Planning & Zoning Board

Thursday, November 16, 2023

RE: Richard Holmes; 7305 E. Main Street: Variance Application

Below is the staff review of the above referenced Variance Application.

SHEET TITLE:
ELEVATIONS

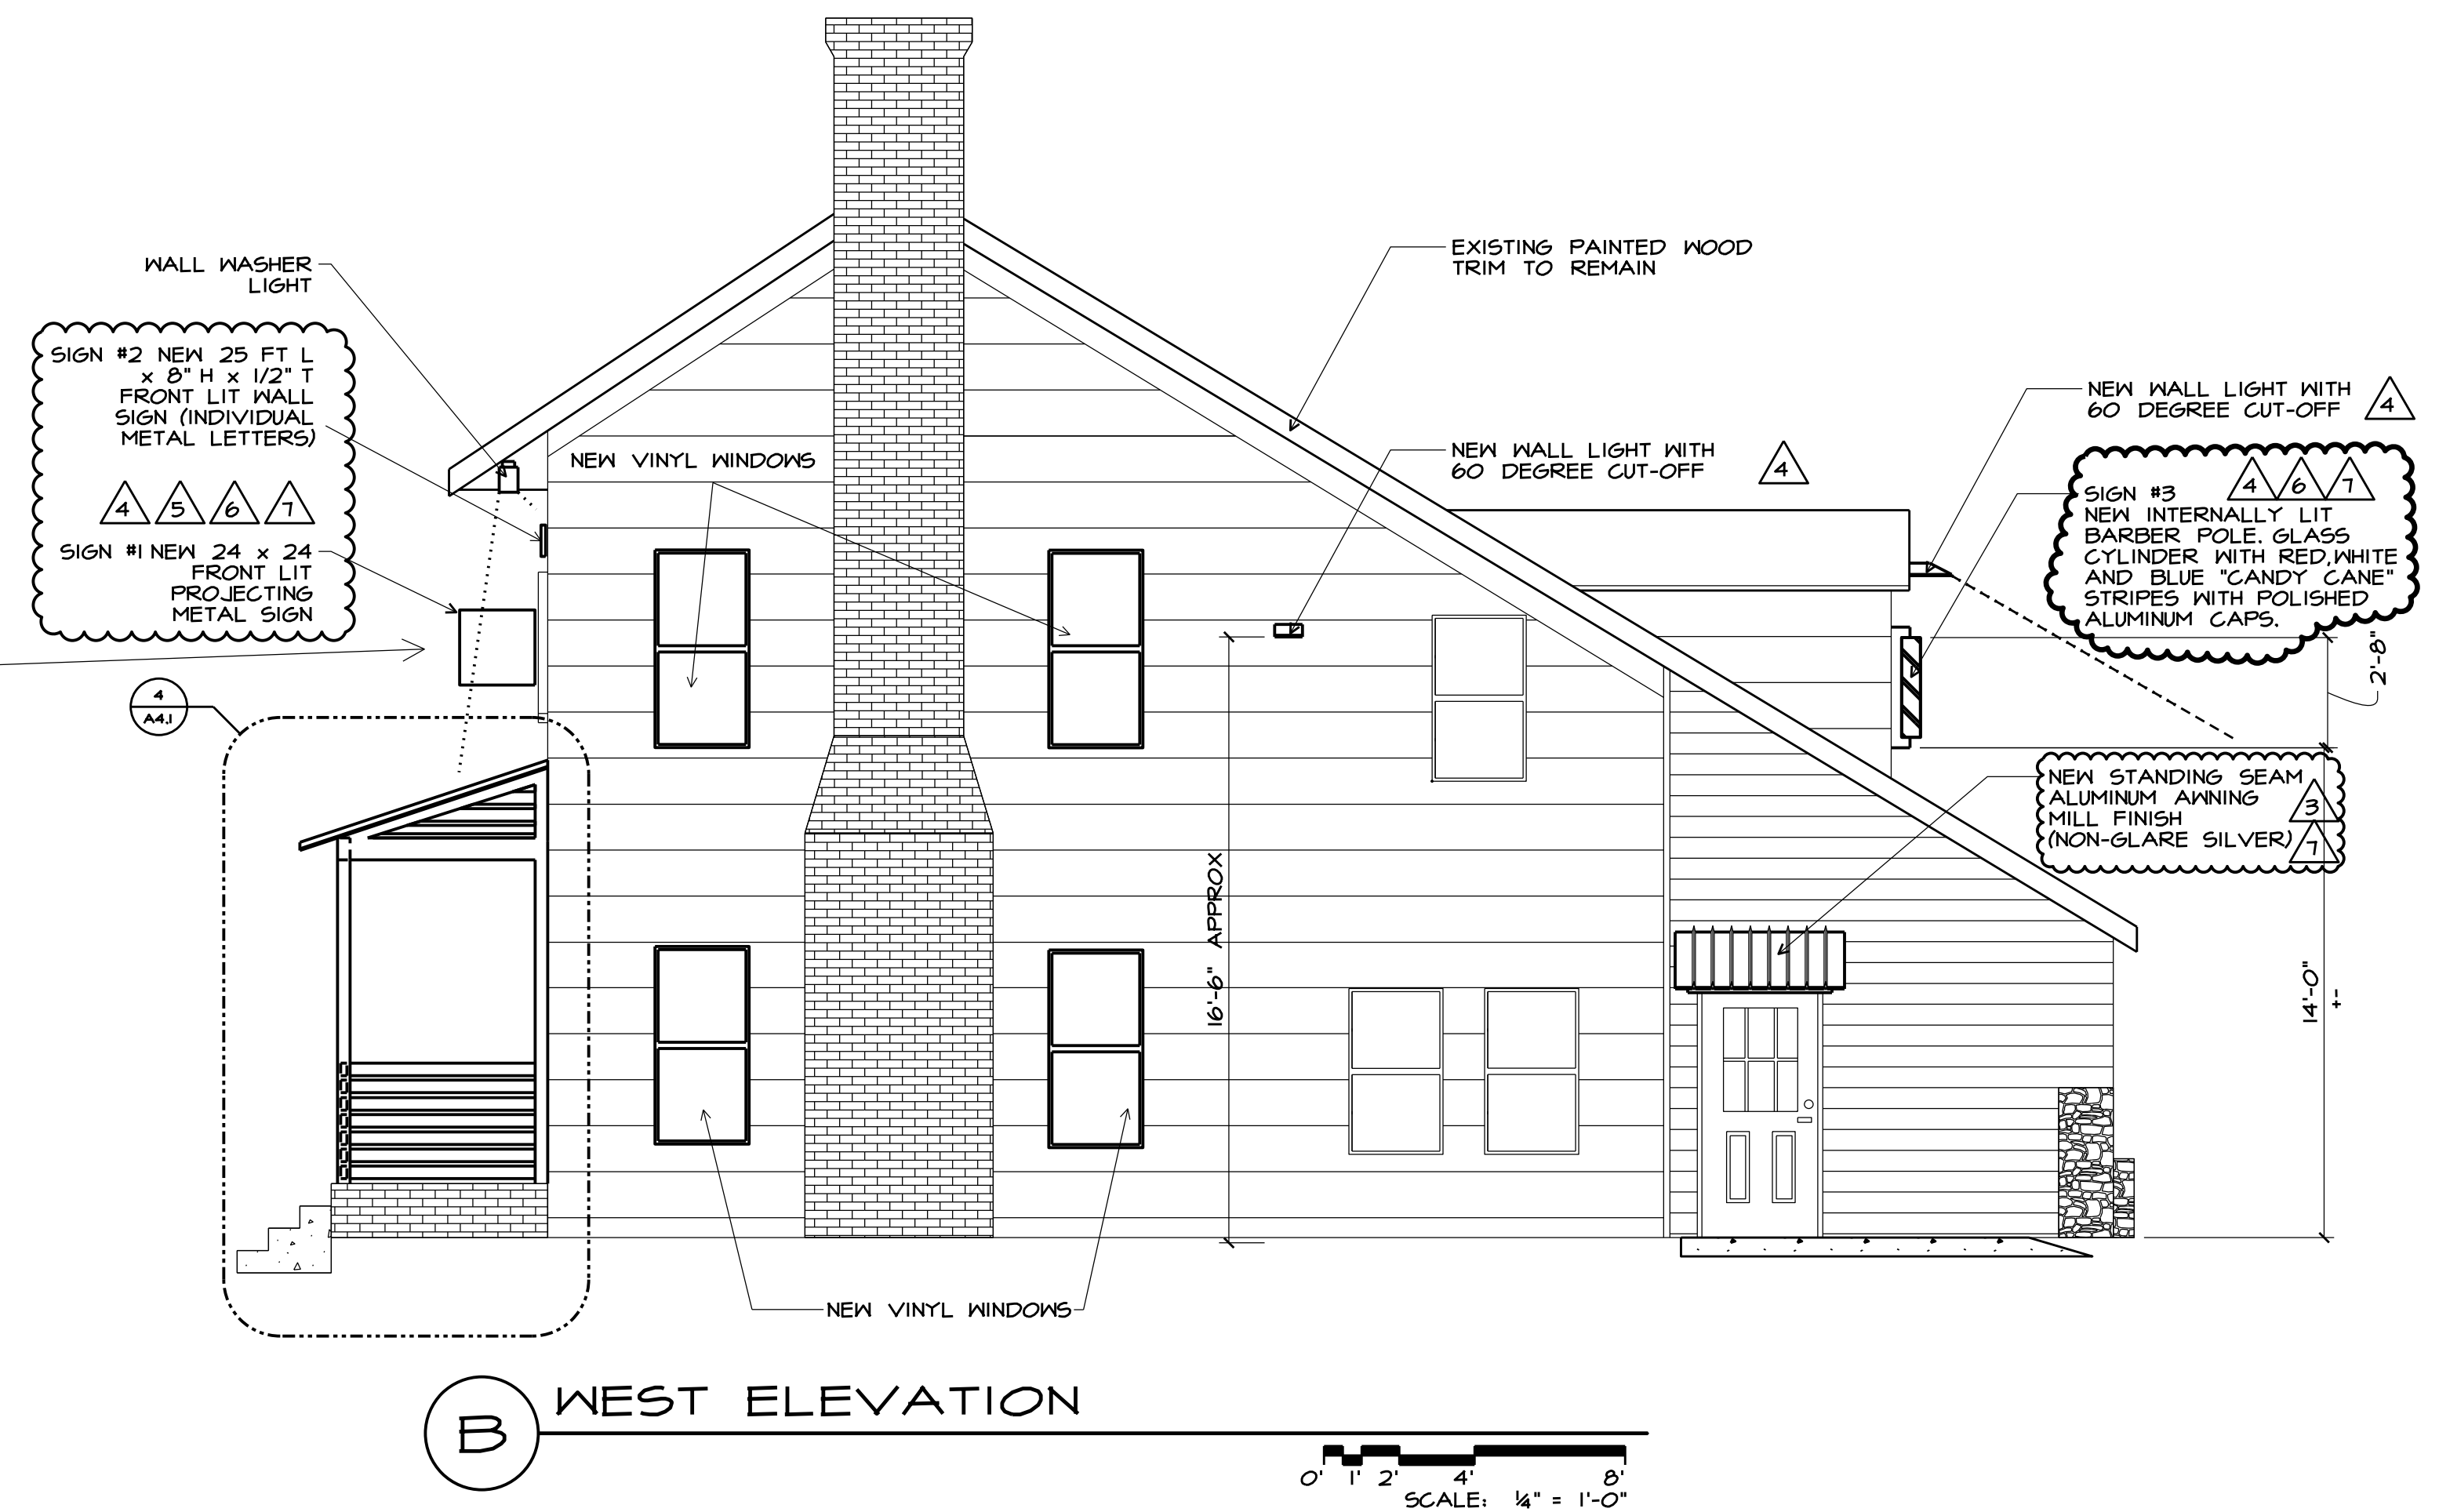
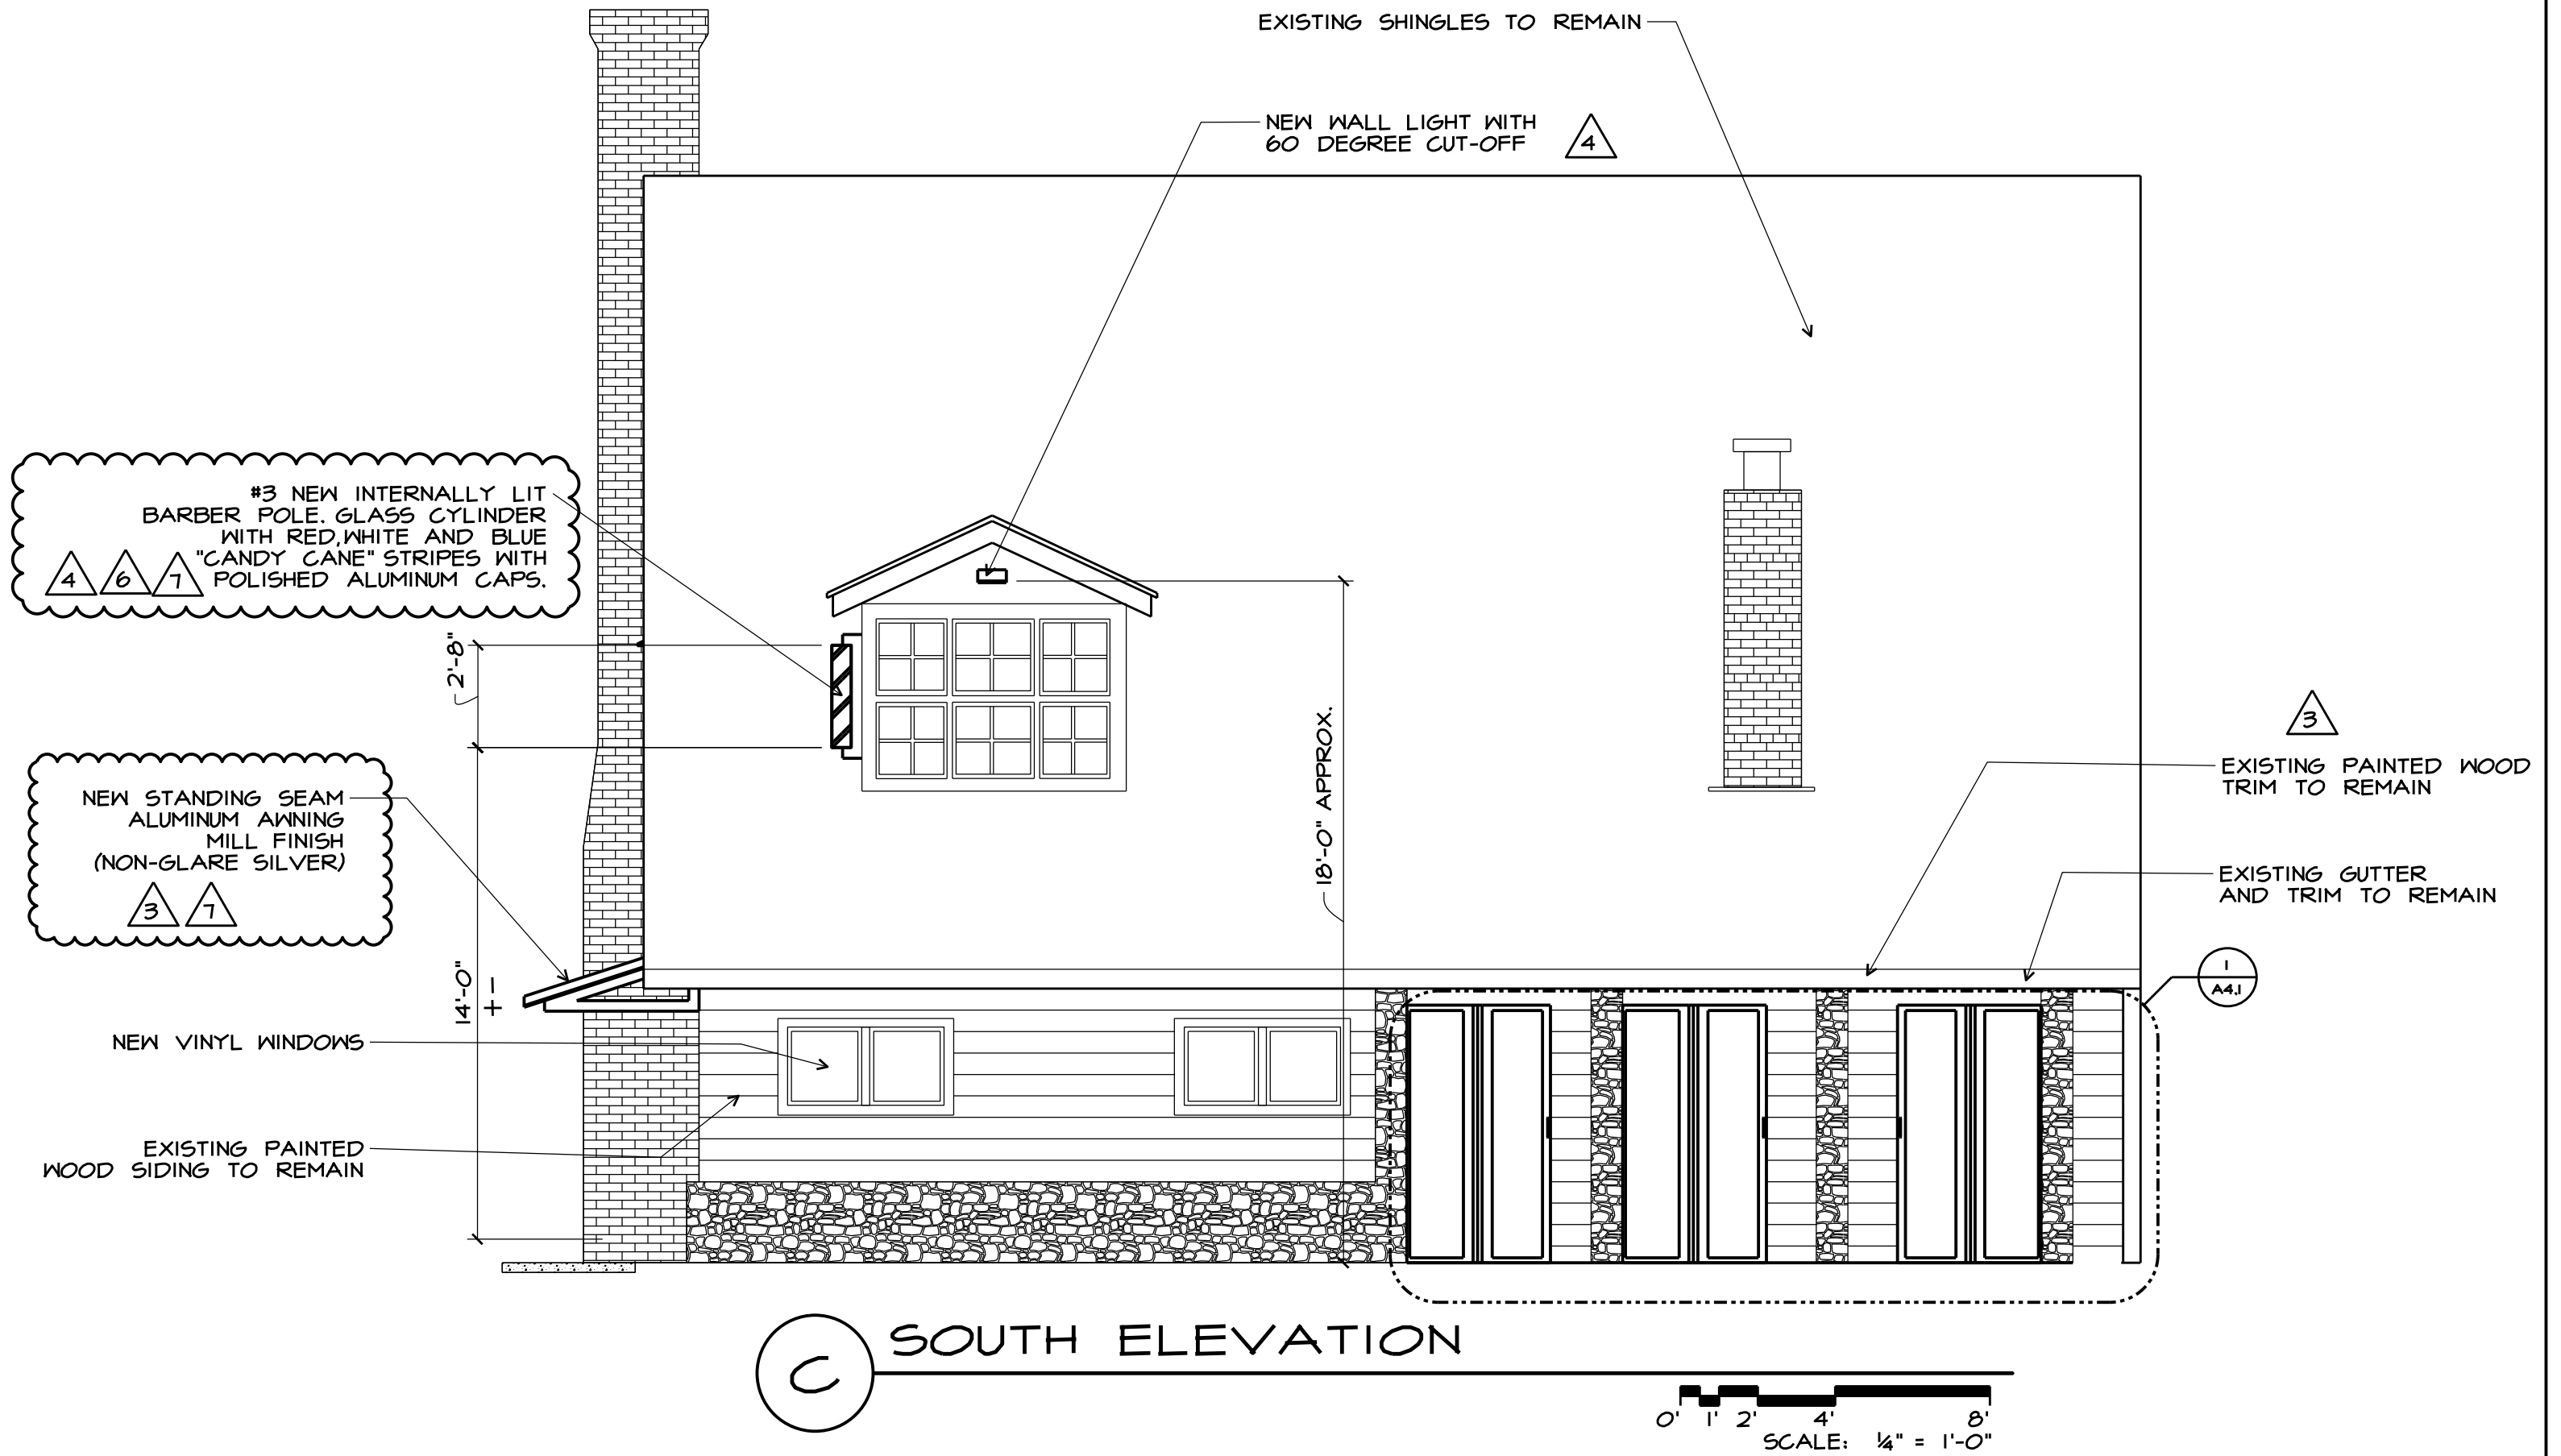
1. The applicant is proposing to have the north elevations wall and projecting sign to be externally illuminated via front lit wall lighting. The zoning code does not call out front lit wall lighting as a permitted type of exterior illumination.

2. The applicant is also proposing to allow the south elevation projecting sign to be internally illuminated. The zoning code does not permit internally illuminated signs in the ORD-C district.

1. The applicant is proposing three (3) signs total, two (2) projecting signs and one (1) wall sign. The zoning code only permits a total of 2 signs on each lot.

1. The applicant is requesting the south elevation projecting sign material of a glass cylinder be permitted. The zoning code only allows projecting signs to be made of wood or metal.

3. Recommendations
 - a. Staff recommends denial of the following variances, Section 1105.03.C.v to permit one additional sign, and Section 1105.03.C.iii to permit internally illumination based on the following reasons:

- ii. The request for internally illuminated signage appears to be a matter of convenience. The applicant does not state in their statement of hardship why the proposed sign is required to be internally illuminated, when it could easily be externally illuminated on the site. Staff is of the opinion granting internal illumination of a sign on the subject site, would set a future precedent to all internal illumination on other properties, when the intent of the zoning code is for external illumination only in the ORD-C zoning district.

- b. Staff recommends approval of the following variances, Section 1105.03.C.v.2 to

permit glass as a permitted projecting sign material, and Section 1105.03.C.iii to permit front lit external illumination based on the following reasons:

- i. The request to allow glass as a permitted projecting sign material is not consistent with the permitted materials found in Section 1105.03.C.v.2, however staff is of the opinion that in this instance, due to the unique nature of the sign, in that is specifically a barber pole, that the material of glass be permitted. Glass is also not a standard sign material generally used for signage, however a barber pole consistently is made of glass, and in and of itself is a unique identifier as a sign. Due to the sign being a barber pole, and the land use being a barbershop, staff would recommend approval of the requested glass material for this specific projecting sign.

- ii. Staff also recommends approval of front lit external lighting for proposed signage on the subject site. The zoning code identifies different types of external illumination, however it does not identify front lit lighting. With the unique architecture of the existing building and location of signage, staff recommends approval of front lit external lighting. Staff is of the opinion that external lighting in the ORD –C zoning district is the intended lighting for this district. That allowing front lit external lighting would be consistent with the intended lighting of the zoning code.
